City of Richmond

Report to Committee

File: RZ 18-825323

Re: Application by CDS-Chen Design Studio Ltd. for Rezoning at
6560 Granville Avenue from the "Single Detached (RS1/E)" Zone to the "Compact
Single Detached (RC2)" Zone

SITE PLAN
Drawing Title:
Drawing No.:
Project No.:
Drawing Date:

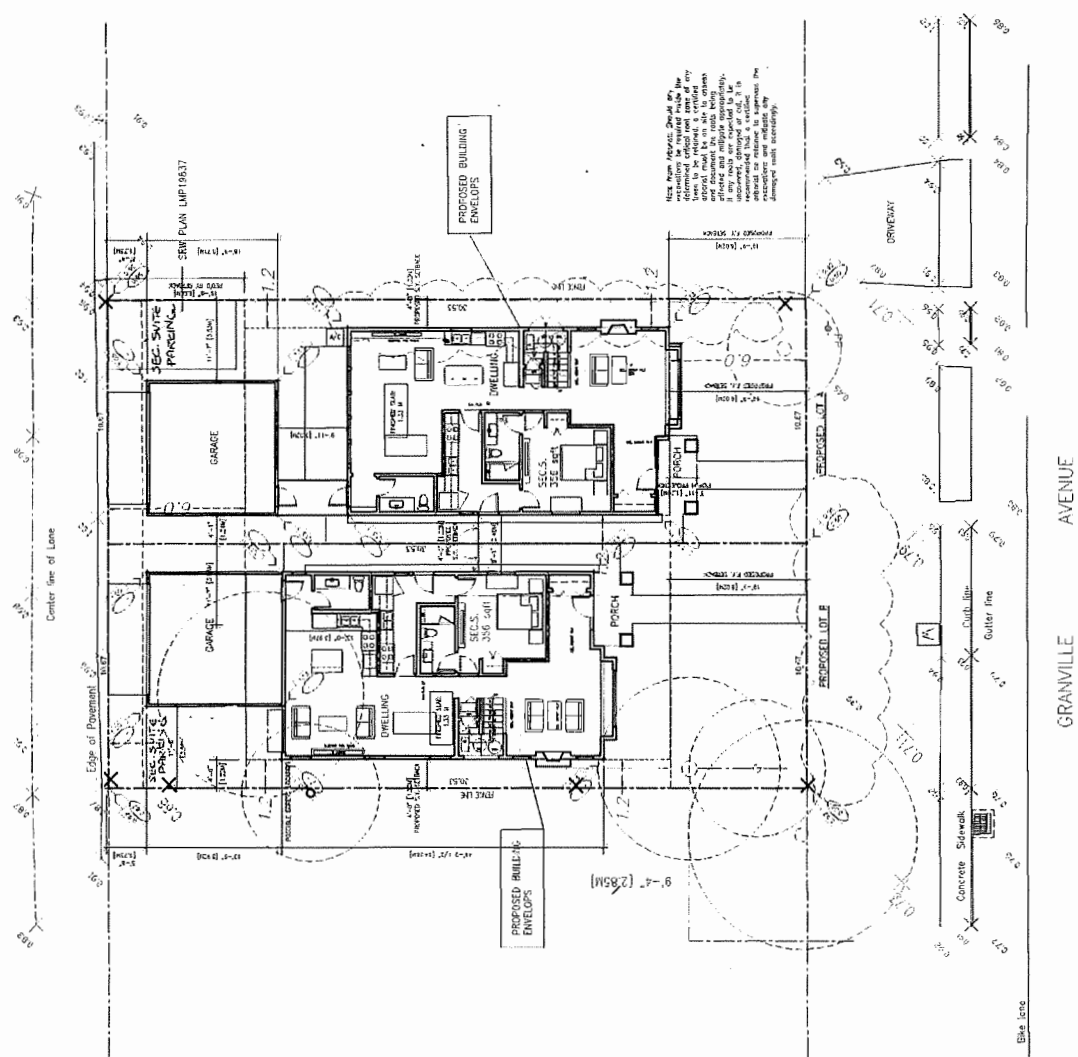
The proposed development is generally in compliance with the “Compact Single Detached (RC2)” zone in Richmond Zoning Bylaw 8500. However, in order to provide a 4 m tree protection fencing area around Tree# 53 and Tree# 54, an increased front yard setback is required. This would result in a shifted building footprint towards the rear which then in turn impacts the rear yard setback to the garage as well as the provision of private outdoor space. If building separation between the house and the garage was available and compliant with “Compact Single Detached (RC2)” zoning, the rear yard setback would be a minimum of 1.2 m. By reducing the rear yard setback requirement of 6.0 m to 1.73 m, an attached garage can be provided, the front yard trees can be protected, and the 1.5 m wide SRW for City Utilities along the rear lot line respected. With the building footprint on Lot B shifted towards the rear, tree protection and secondary suite parking requirements, the private outdoor space will need to be included in the front yard instead of the rear yard. Therefore, a variance will be required to amend the regulation of a minimum of 20 m² of private outdoor space on the lot outside of the front yard.

The applicant is requesting two variances to reduce the minimum rear yard setback in Lot B from 6.0 m to 1.73 m for a one storey garage to be attached to a proposed single-family dwelling zoned “Compact Single Detached (RC2)”, and to allow the minimum 20 m² of private outdoor space to be provided in the front yard on Lot B.

Staff support the requested variance as the Arterial Road Guidelines for Compact Lot Development in the OCP encourage retaining existing trees wherever possible, particularly if the trees are in the front yard. The requested variances will enable successful retention of the tree and further use of the front yard space. The variances will be considered through a Development Variance Permit (DVP) process which would follow the adoption of the rezoning bylaw. Subdivision approval is required prior to DVP issuance as the variances are requested for Lot B only.

Tree Management Plan

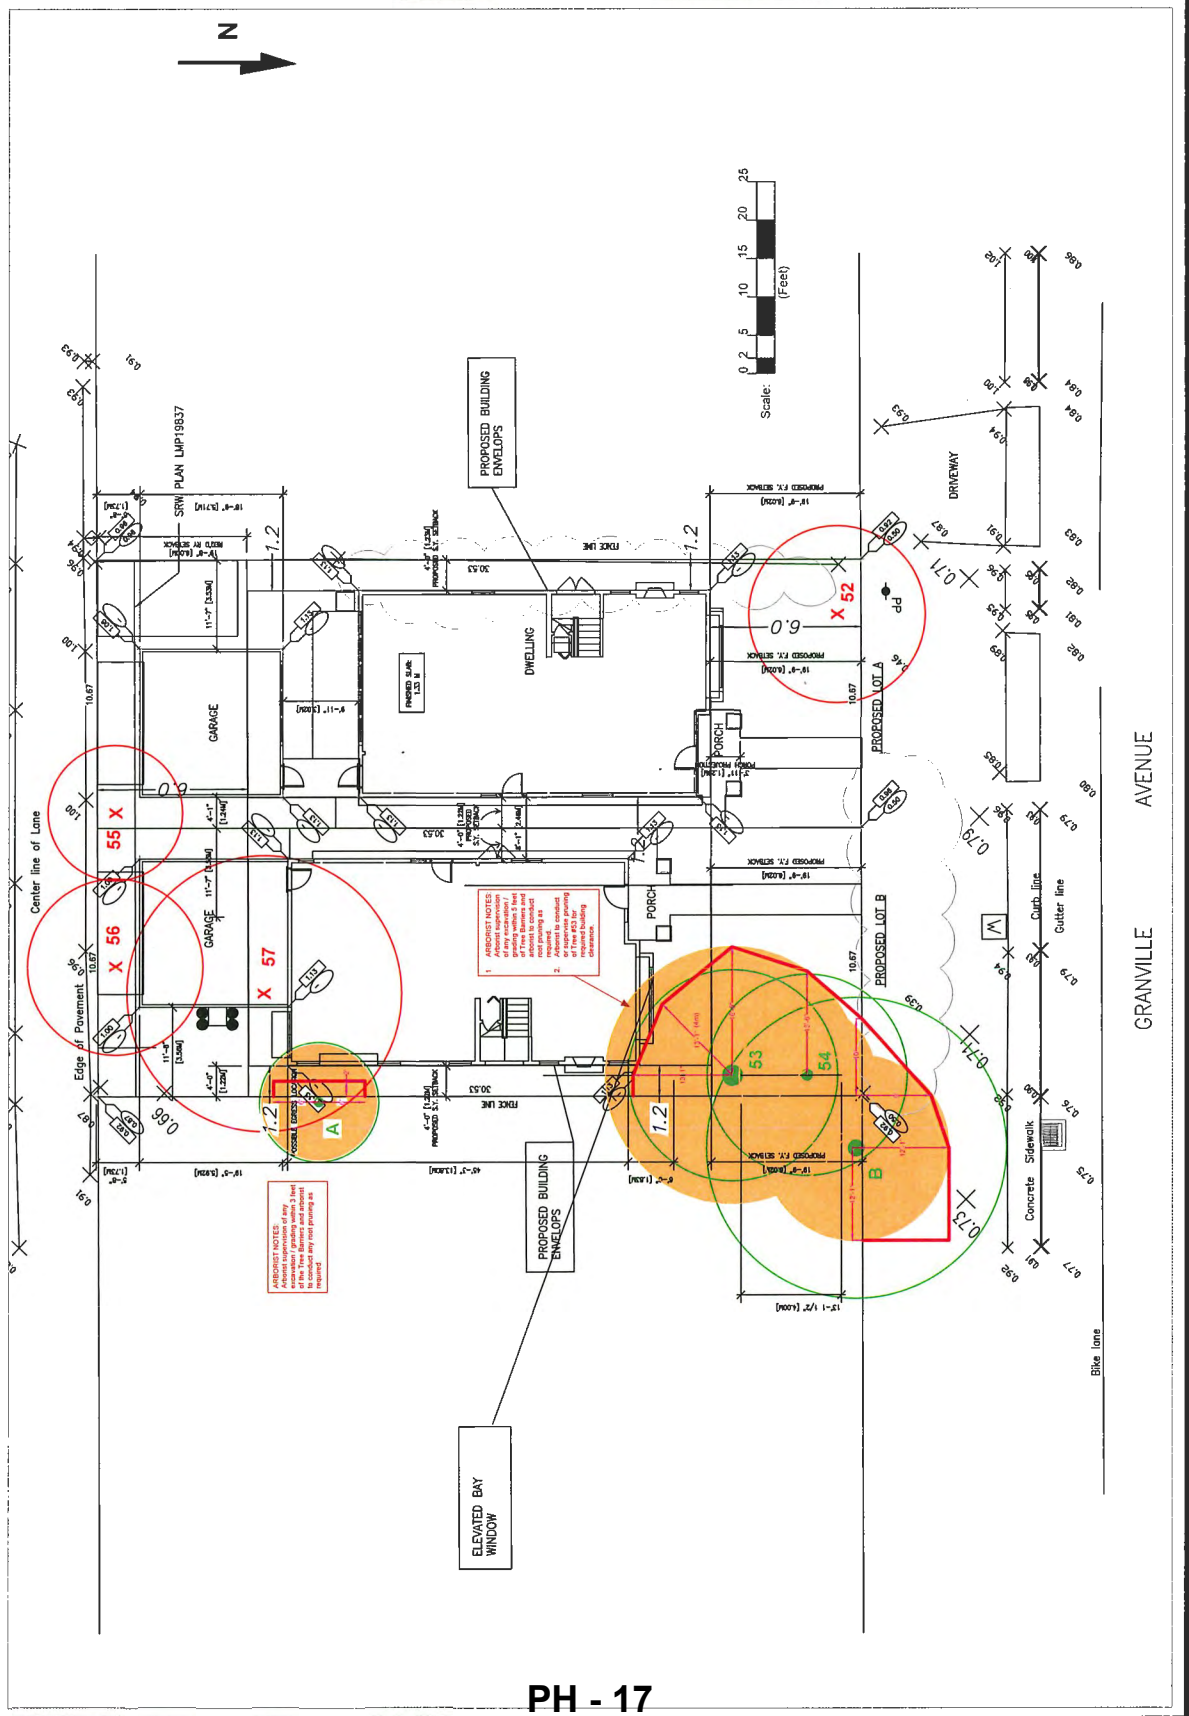
The City's Tree Preservation Coordinator has reviewed the Arborist's Report and supports the Arborist's findings, with the following comments:

- One Cypress tree (Tree# 52, multi-stem 48 cm dbh) and one Rubinia tree (Tree# 57, multi-stem 34 cm dbh) located on the development site are either dead, dying (sparse canopy foliage), infected with Fungal Blight or exhibit structural defects such as cavities at the main branch union and co-dominant stems with inclusions. As a result, these trees are not good candidates for retention and should be replaced.

- Two Cypress trees (Tree# 53, multi-stem 54 cm dbh; Tree# 54, 43 cm dbh) located on the subject property are in fair to good condition. Tree# 53 is just outside of the allowable building envelope and Tree# 54 is located outside the proposed building envelope. In order to protect both trees as per the Tree Protection Bylaw 8057, trees will require a minimum of 4 m of tree protection area from the base of the stems for successful retention. To ensure this retention is successful, the front yard setback needs to be significantly increased from 6.0 m to 8.6 m. This then triggers the need to provide a house with an attached garage on Lot B due to the shift of the building footprint to the rear to accommodate the front yard trees. In order to comply with zoning requirements for an attached garage a separate Development Variance Permit will be required to enable a reduced rear yard setback from 6.0 m to 1.73 m allowing an attached garage in the rear yard and tree protection in the front yard. The relocation of private outdoor space to the front yard will also require a variance as an attached garage and secondary suite parking would limit the availability of space in the rear yard.

- Two undersized trees, one Pear (Tree# 55), and one Plum (Tree# 56), located on the development site and along the rear property line are in fair to poor condition. With existing stem defects, structural damage, poor quality pruning, and conflict with the proposed driveway access and new sanitary connections, these trees are not good candidates for retention and should be removed.

- One Cedar tree (Tree# A, 43 cm dbh) and one Fir tree (Tree# B, 62 cm dbh) located on the neighbouring property to the east are to be protected as per City of Richmond Tree Protection Information Bulletin Tree-03.

- Replacement trees should be specified at 2:1 ratio as per the OCP.

Two trees (Tree# 53, 54) on the subject property and two trees (Tree# A, B) on the eastern neighbouring property are to be retained and protected. The applicant has submitted a tree protection plan showing the trees to be retained and the measures taken to protect them during development stage (Attachment 5). To ensure that the trees identified for retention are protected at development stage, the applicant is required to complete the following items:
